## Index 18113 Concrete CCTV Pole

All Sheets: Redeveloped Index.

Consolidated relevant information from Indexes 18100, 18101, 18102, 18104, 18105, 18107, and 18108, which were deleted for the Standards Plans for the FY 2018-19 release.

**BLACK** = Industry Review Comments    **RED** = Standard Plans Response

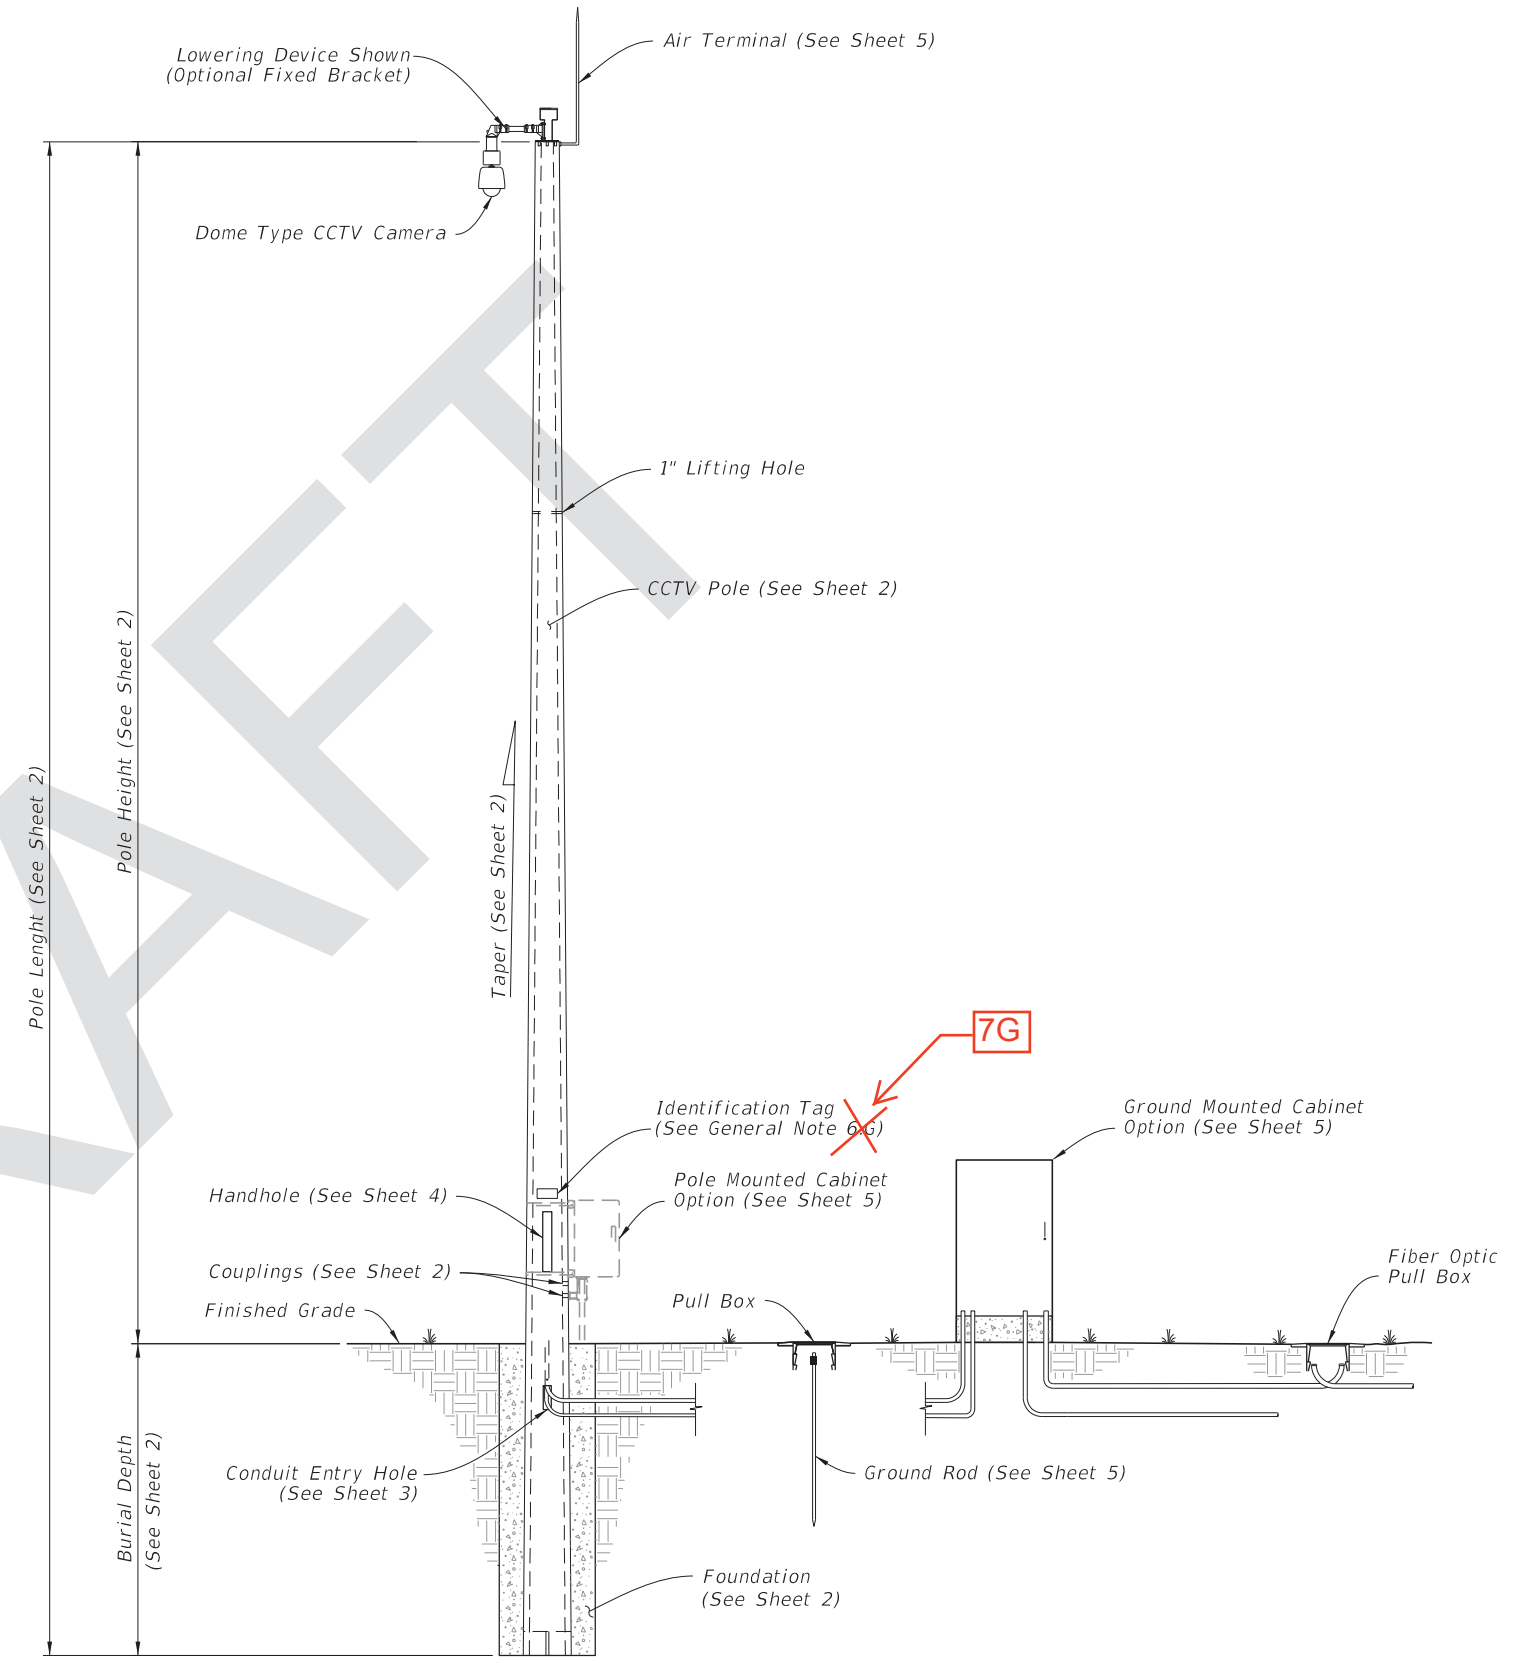
Sheet 5 of 5 – There are duplicate “Conduit Entry Hole” tags in the ground mount cabinet detail on the bottom left of the sheet. One says to SEE SHEET 5 and the other says SEE SHEET 3. The SEE SHEET 5 one should be removed.

Agreed, Change Made.
